CONVAIR

COMMERCIAL CHANGE PROPOSAL

SPEC NO.: ZD- 22-002

MODEL: (880) 22-1

Enclosure to CCP No. 185A

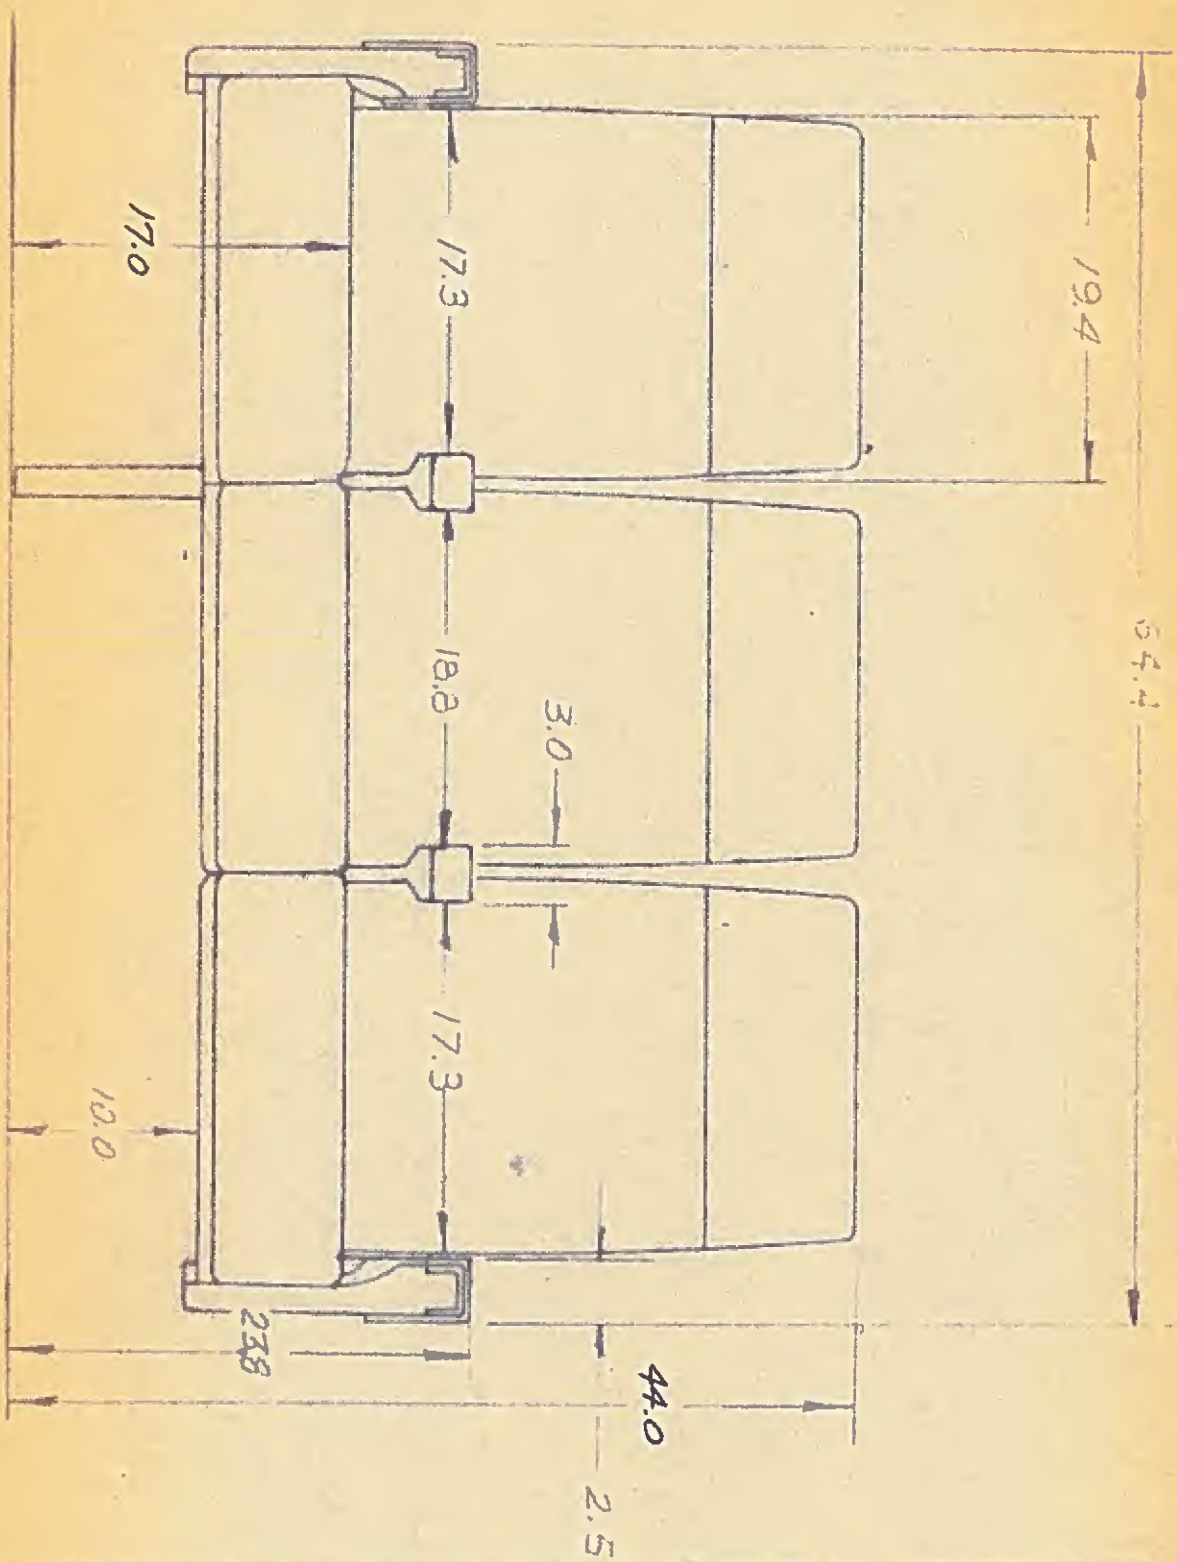
No mock-up or prototype coach seats have been included in this proposal.

Equipment interchangeability for standard seats, as covered in CCP No. 104B, is also applicable to coach seats.

Item "A" is paragraph 3.19.1.1.5.2 of this proposal, will provide five plug-in trays for first six rows of Customer order per airplane. Five additional plug-in trays will be provided for 18 or more coach seat rows per airplane. Receptacles for plug-in trays shall be provided as loose equipment on all coach seats not having receptacles installed.

Enclosure: (A) One (1) copy of sketch on proposed position light
locations (for information only).

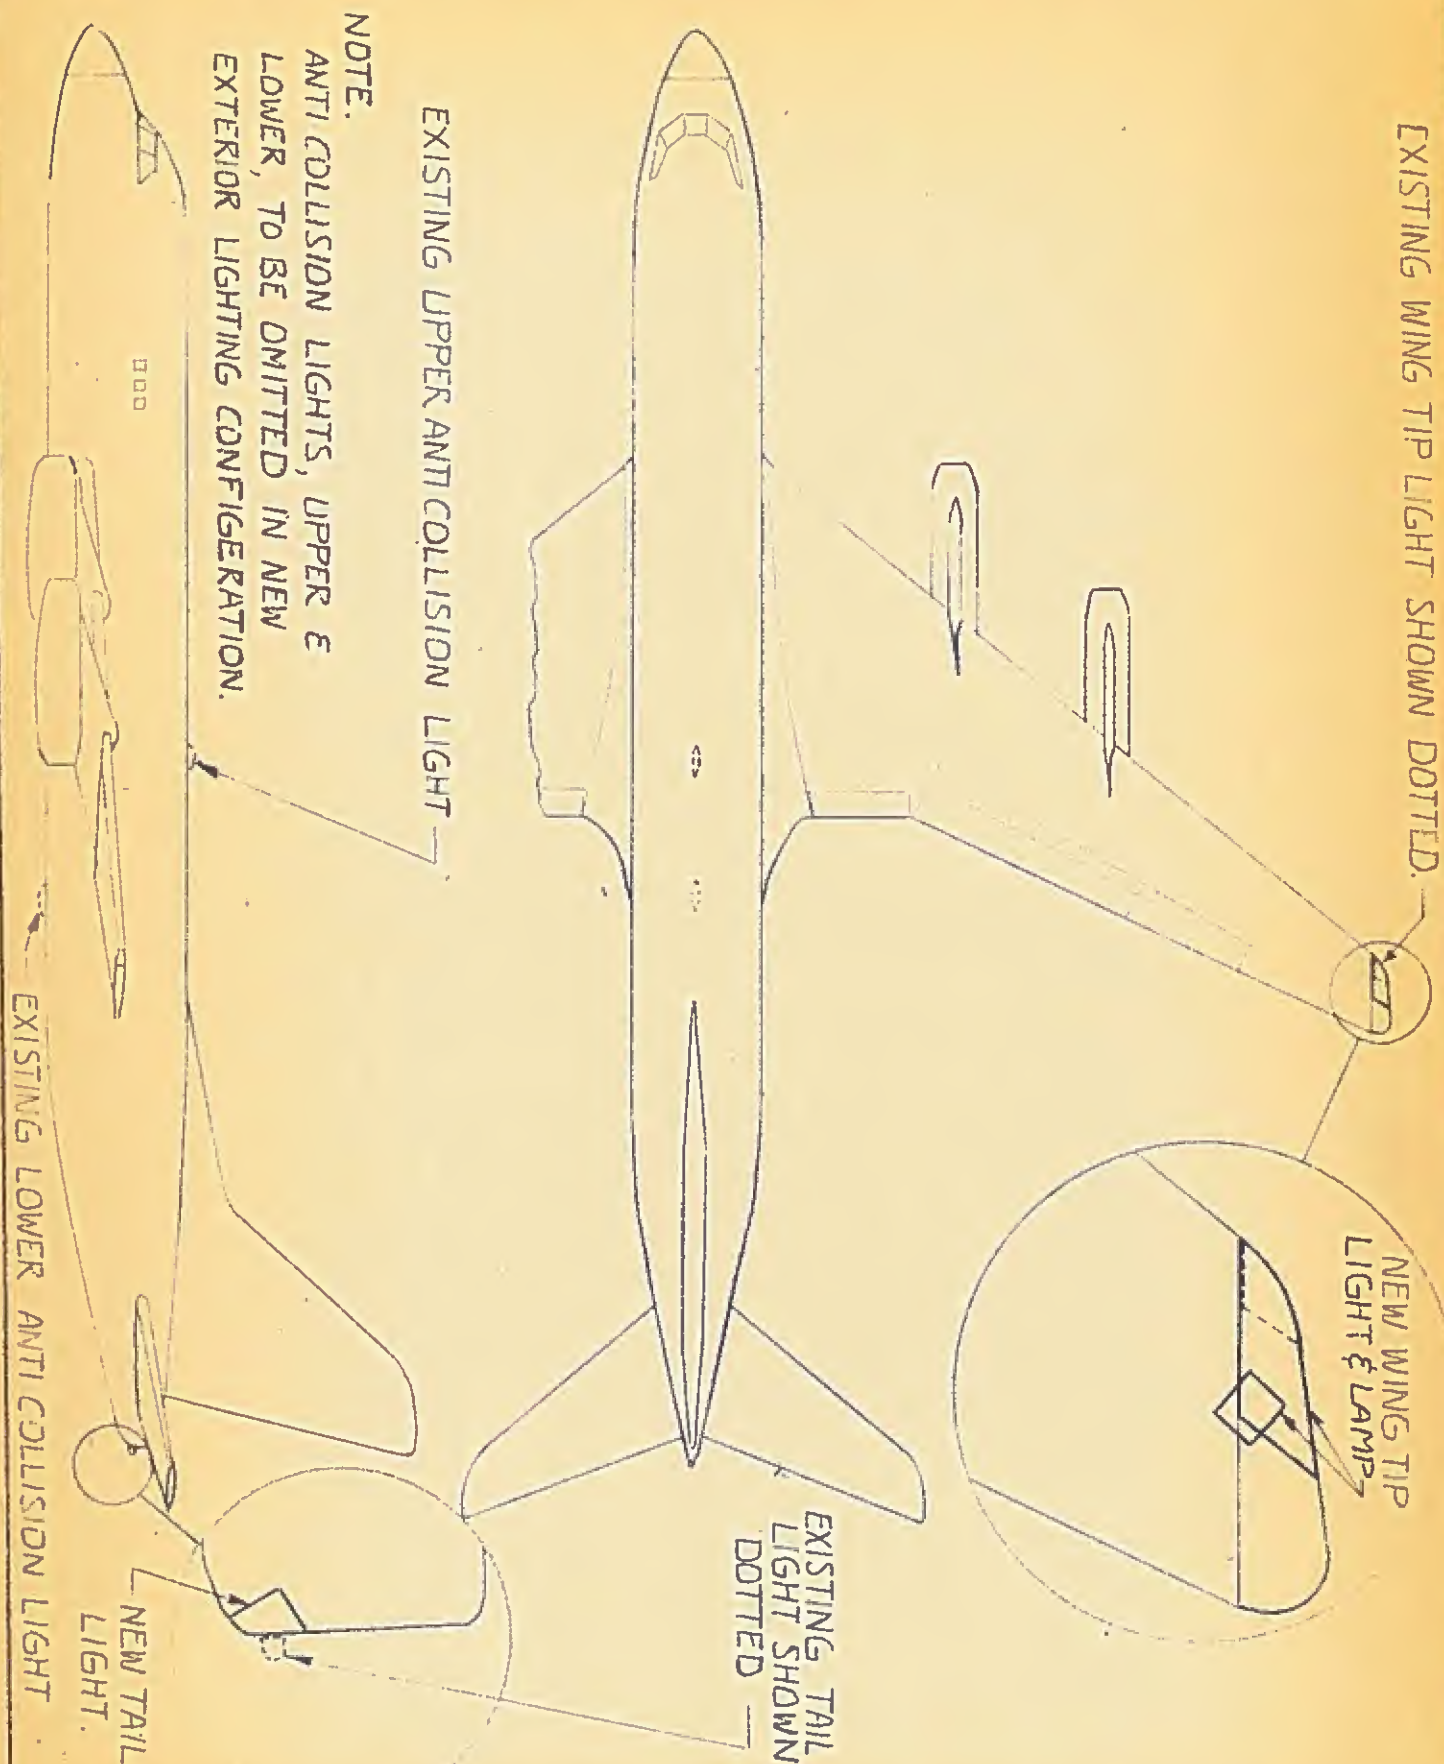
From: "1 Tail Position Light, Grimes B7890-1-311"

To: "1 Position Light Assembly, Aft, Oscillating, White"

12-PLACE CLUB AREA

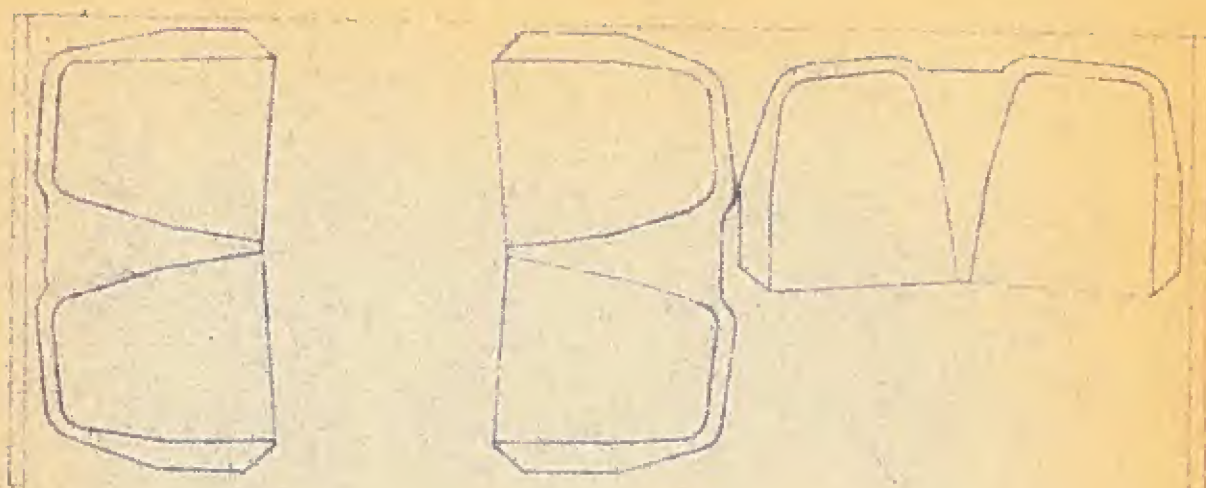
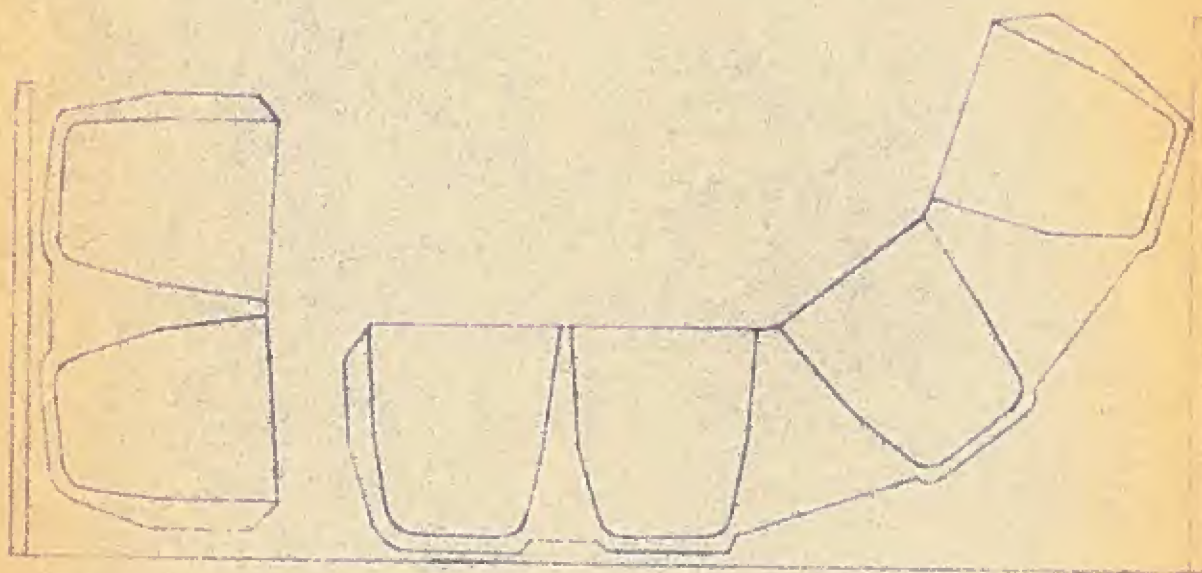
Enclosure: (A) One (1) copy of sketch of proposed Club Area Arrangement

AIRLINE SCHEDULE HOLDER

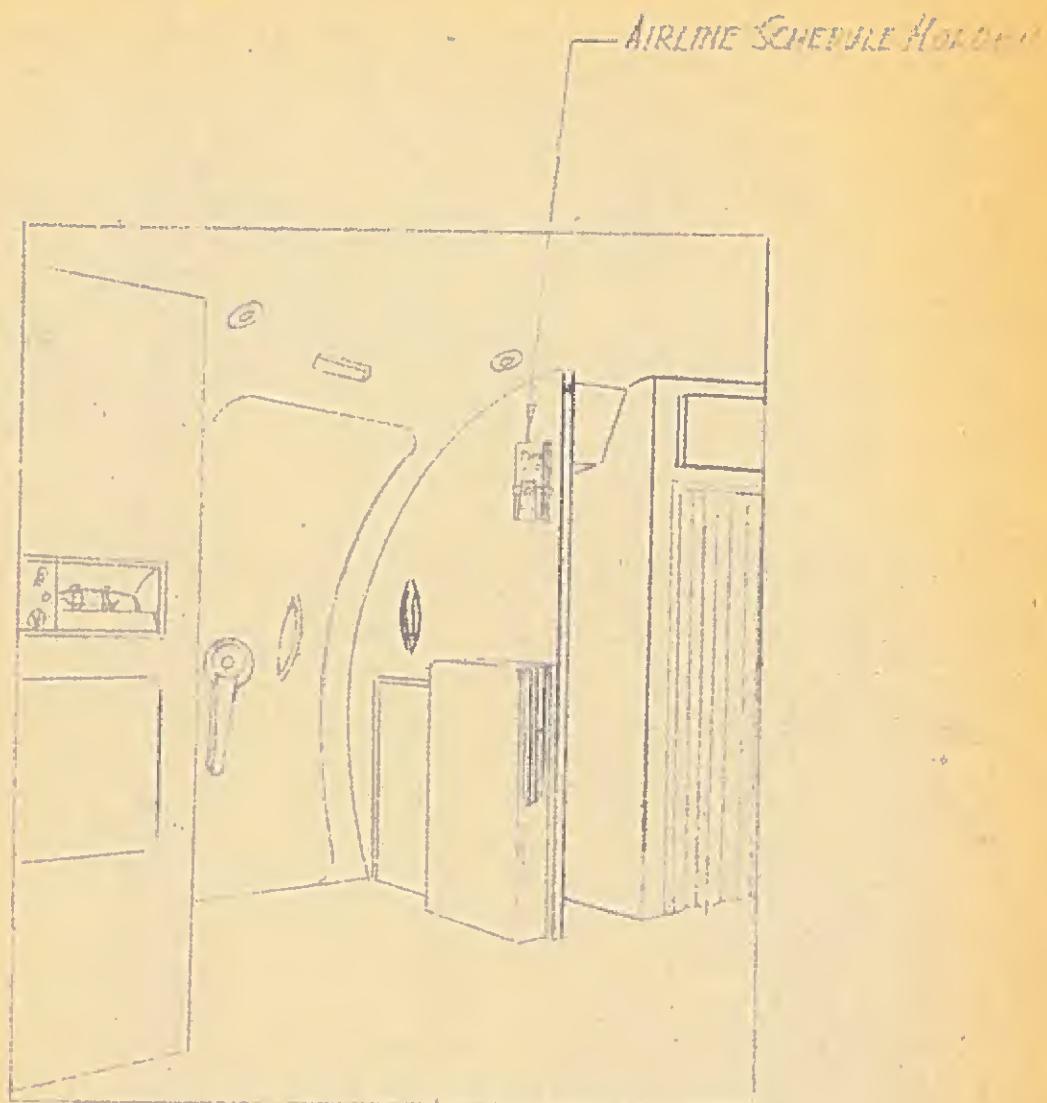
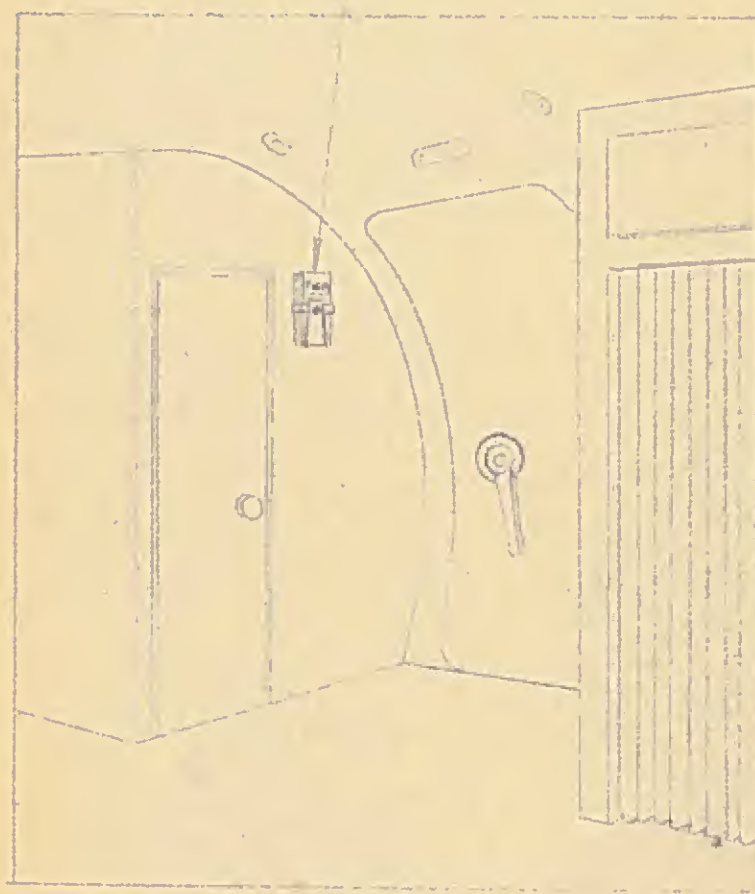
Page 114, Add the following new paragraph to the page after paragraph 3.19.3.6:

FIGURE 3.19-9

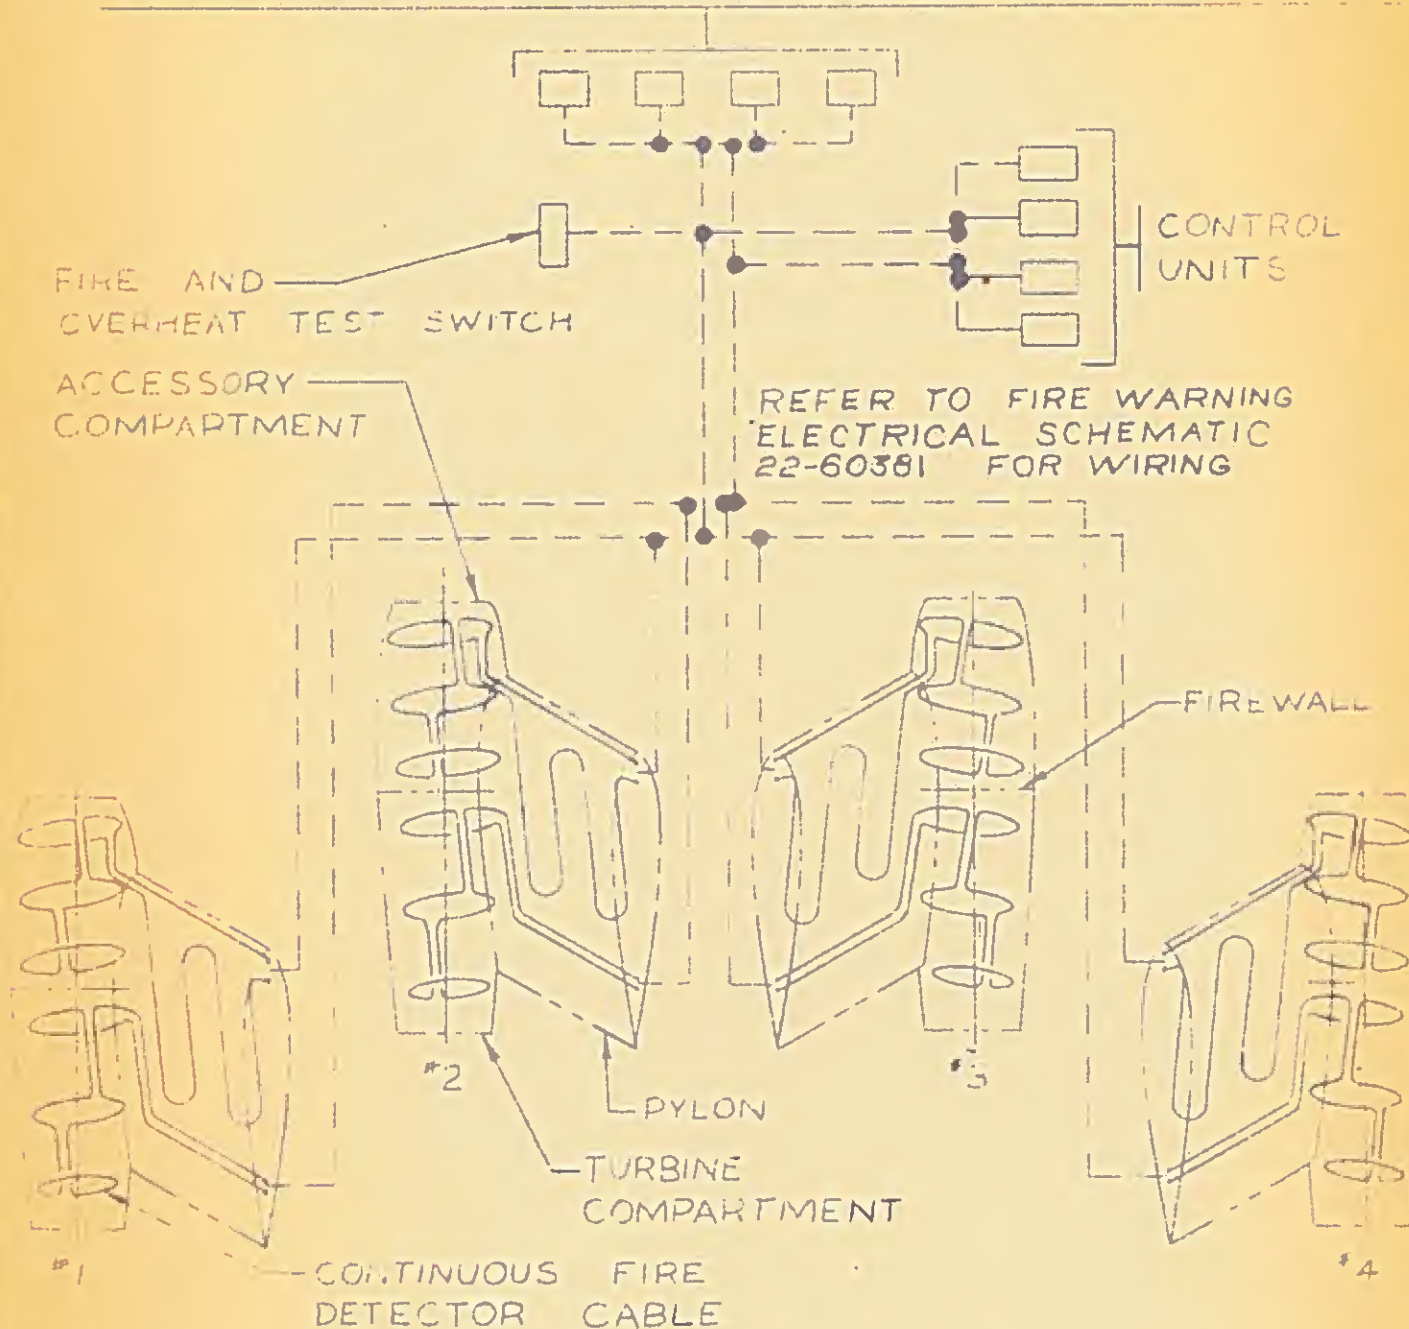
Enclosure (A): One (1) copy of Figure 3.19-9 FIRE DETECTOR SYSTEM,
ENGINE NACELLES AND PYLONS (revised 1-23-58)

FIGURE 3.20-1

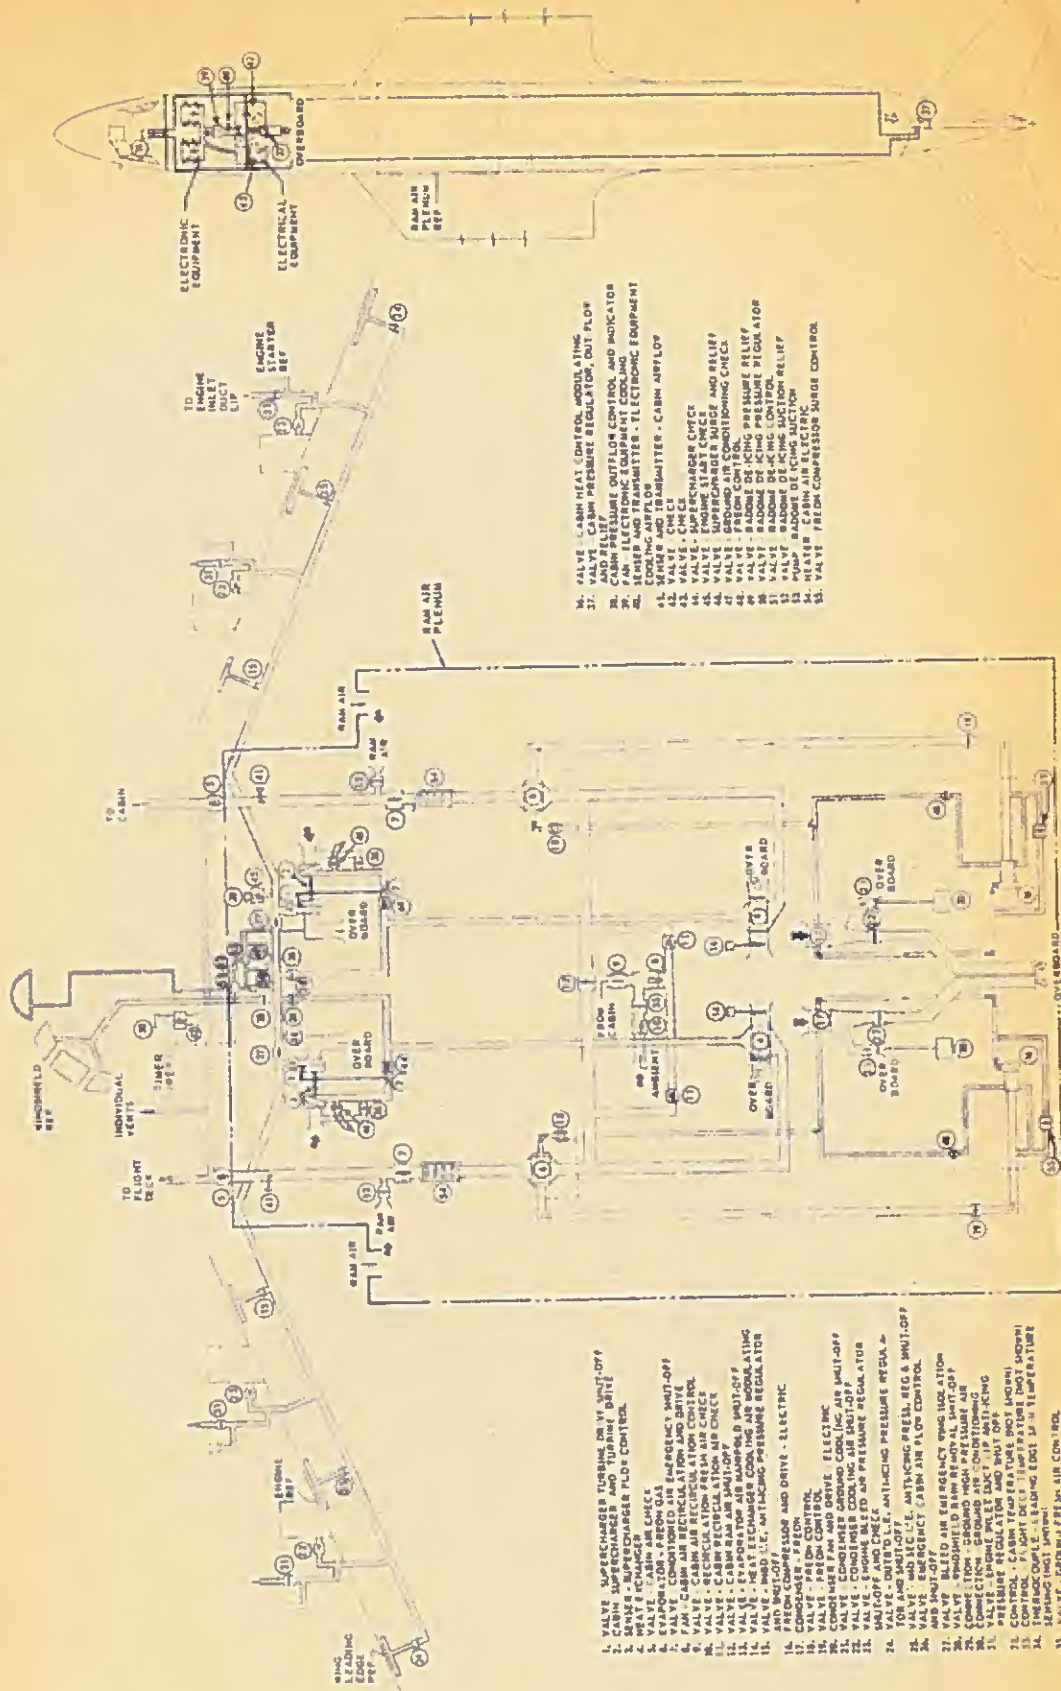
Enclosure: (A) One (1) copy of Figure 3.20-1 AIR CONDITIONING PRESSURIZATION SYSTEM
